Council Agenda Report

Subject: Appeal No. 21-011 - Appeal of Planning Commission Resolution No. 21-53 (23325 Malibu Colony Drive; Owner, Axel 23324, LLC; Appellant, Judith Israel)

RECOMMENDED ACTION: Adopt Resolution No. 23-02 (Exhibit A), determining the project is categorically exempt from the California Environmental Quality Act (CEQA), denying Appeal No. 21-011 (Exhibit B) and approving Coastal Development Permit (CDP) No. 18-035 for the demolition of a one-story single-family residence and associated development, totaling 2,963 square feet, and construction of a new 5,146 square foot, two-story single-family residence, swimming pool, decks, permeable driveway and other associated development, and replacement of the onsite wastewater treatment system (OWTS); including Variance (VAR) No. 19-062 to allow encroachment into the 100-foot buffer from an Environmentally Sensitive Habitat Area (ESHA) (Malibu Lagoon) and Demolition (DP) No. 18-010 for the demolition of the existing residence and associated development located in the Single-Family Medium Density (SF-M) zoning district within the Malibu Colony Overlay District at 23325 Malibu Colony Drive (Axel 23324, LLC).

A1.2
 Outdoor Lighting Plan

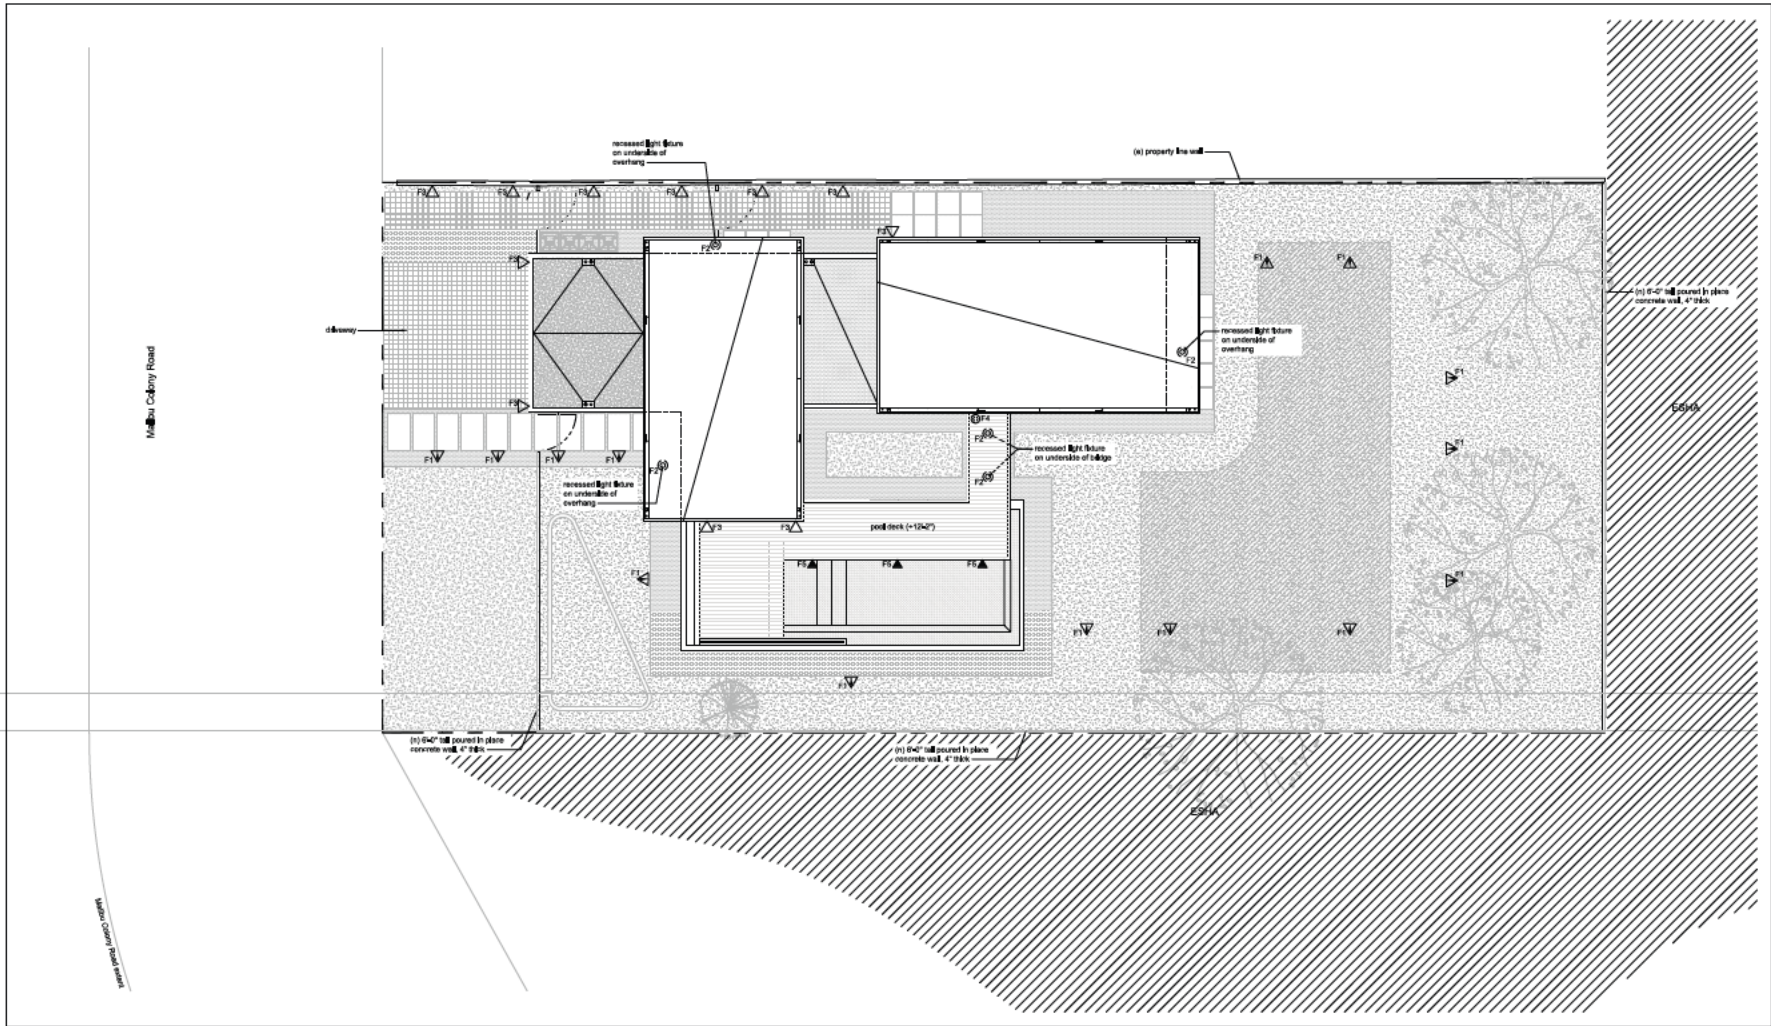
In an attempt to downplay the impact, the applicant claims that all fixtures adjacent to ESHA will "aim away from ESHA." Project Plans, Sheet A1.2, Note 9. However, this does not adequately address the impacts or analyze other feasible alternatives for siting and designing the development, including reducing the height of the residence to avoid new light impacts, as required by the City's LCP. Indeed, in improperly dismissing a one-story Project alternative, City staff again exclusively focused on the development area and the Project's compliance with the Malibu Colony Overlay District development standards without mentioning that the Project failed to comply with ESHA development standards, which are not superseded by the Malibu Colony Overlay District and which take priority over other development standards. City LIP Section 4.6.4. Such disregard for the clear LCP language remains unacceptable.
